**Economic Commission for Europe****Inland Transport Committee****World Forum for Harmonization of Vehicle Regulations****Working Party on Passive Safety Provisions****Seventy-first session**

**UN Regulation No. 129 (Enhanced Child Restraint Systems)****Proposal for Supplement 9 to the 01 series of amendments****Submitted by the expert from the European Association of Automotive Suppliers\***

### "Annex 15

Figure 1  
Conditioning for adjusters mounted directly on Enhanced Child Restraint Systems

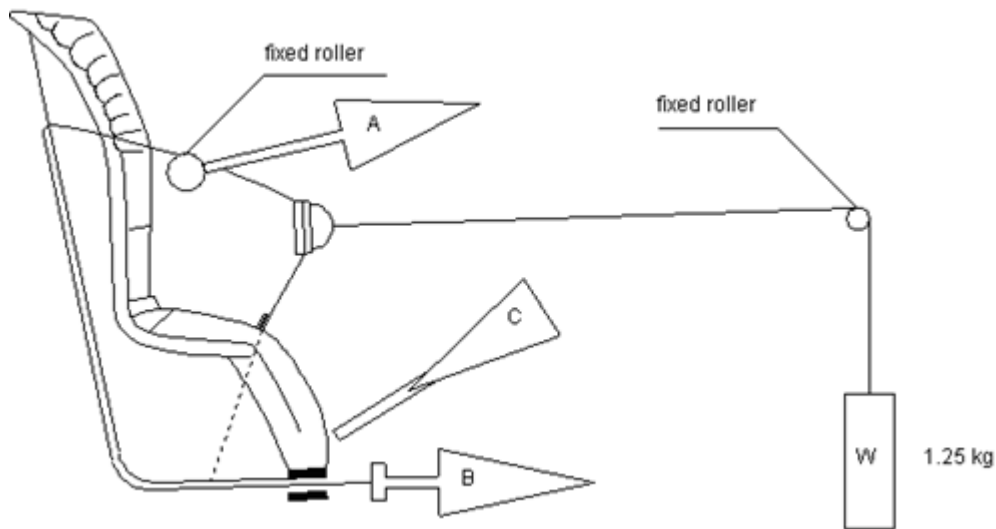
1. **Conditioning for adjusters mounted directly on Enhanced Child Restraint Systems (Figure 1)**
  - 1.1. **Method**
    - 1.1.1. With the webbing set at the reference position described in paragraph 7.2.6.1., withdraw at least 50 mm of webbing from the integral harness by pulling on the free end of the webbing.

This amendment to Annex 15 corrects an editing mistake that was made in proposals adopted at the sixty-first session of the Working Party on Passive Safety and subsequently entered into force in the 01 and 02 series of amendments to UN Regulation No. 129. Specifically, it reinstates a figure and procedure for testing adjusters mounted directly on the Enhanced Child Restraint System, which was mistakenly overwritten, instead of added to, by a figure and procedure for testing adjusters connected to a strap.

**Figure 2**  
**Conditioning for adjusters connected to a strap (not directly mounted on Enhanced Child Restraint Systems)**

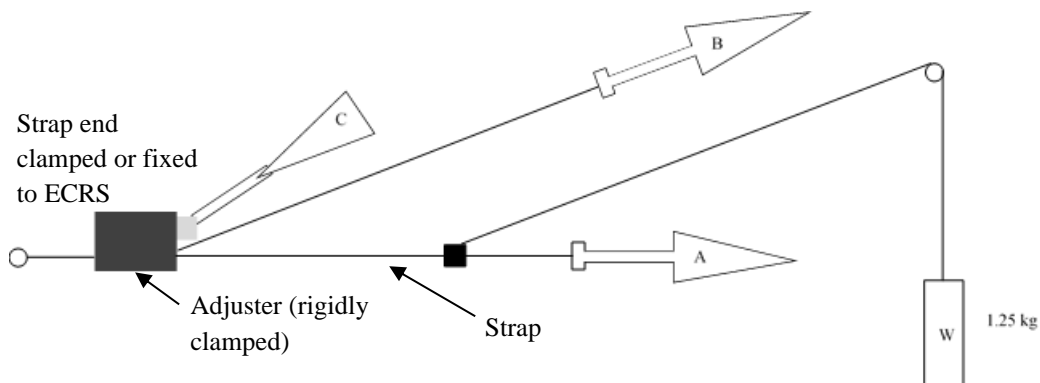
**2. Conditioning for adjusters connected to a strap (not directly mounted on Enhanced Child Restraint Systems) (Figure 2)**

**2.1.1. Rigidly clamp the adjuster**

**2.1.2.** With the strap set at the reference position described in paragraph 7.2.6.2., withdraw at least 50 mm of strap from the adjuster by pulling on the free end of the strap.
